9/12/2000
John Lohmeyer
T10 Chairman

Subject: Proposal for revised setup and hold figures to be included in SPI-4

Figure 42 - LVD timing measurement points for DT = Fast - 160 data transfers

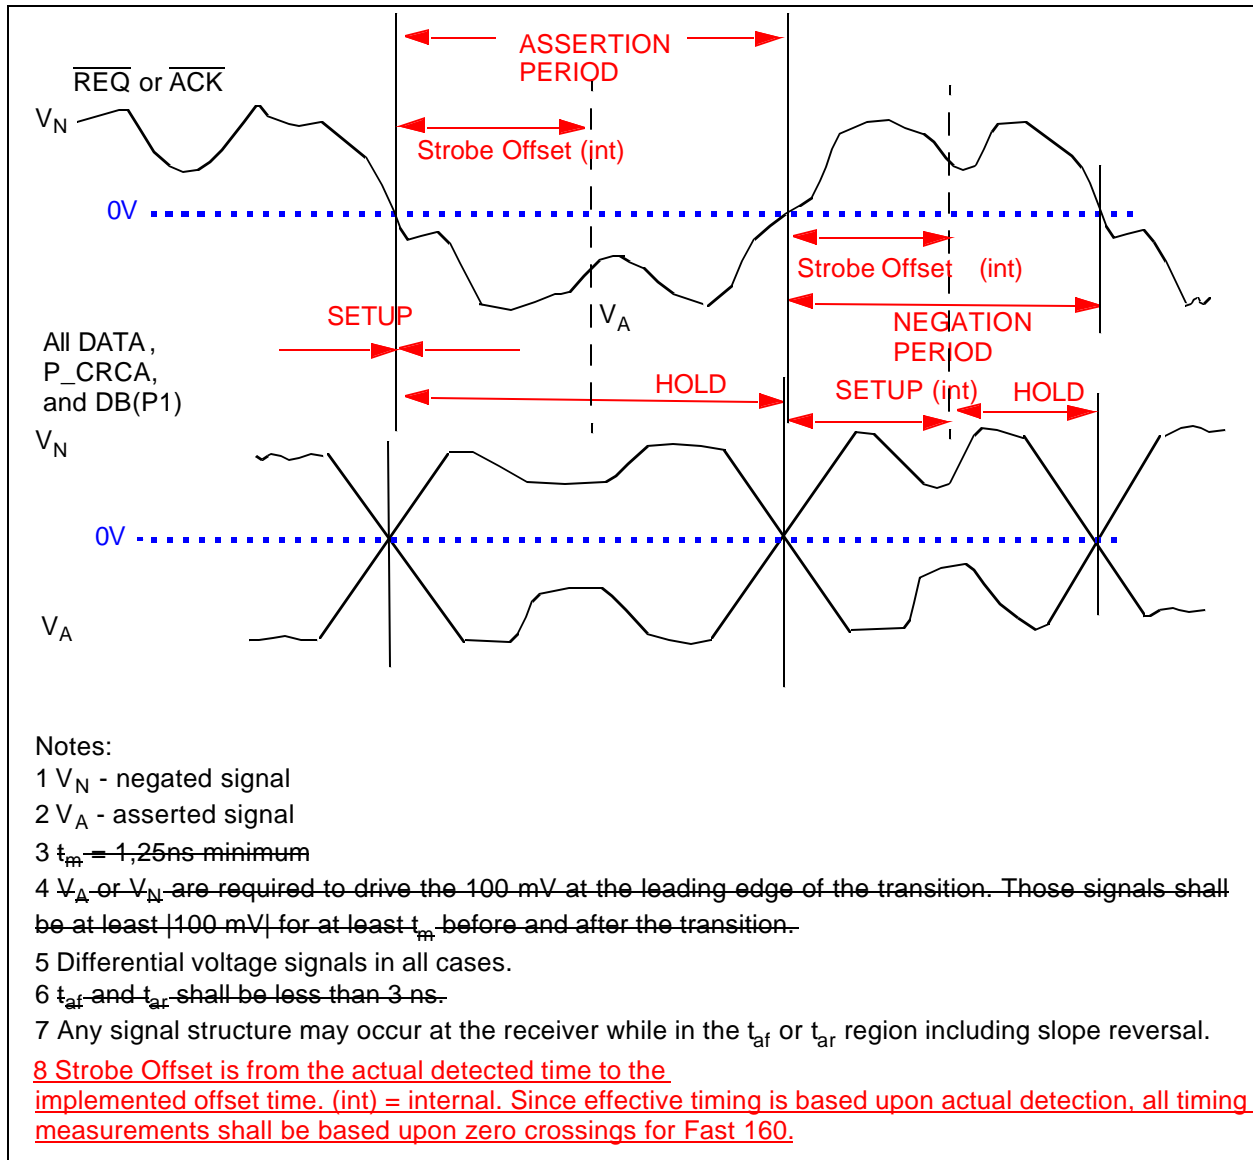
The attached figures have been described and I think agreed to in various working groups as word pictures. This proposal documents the word pictures in FrameMaker.
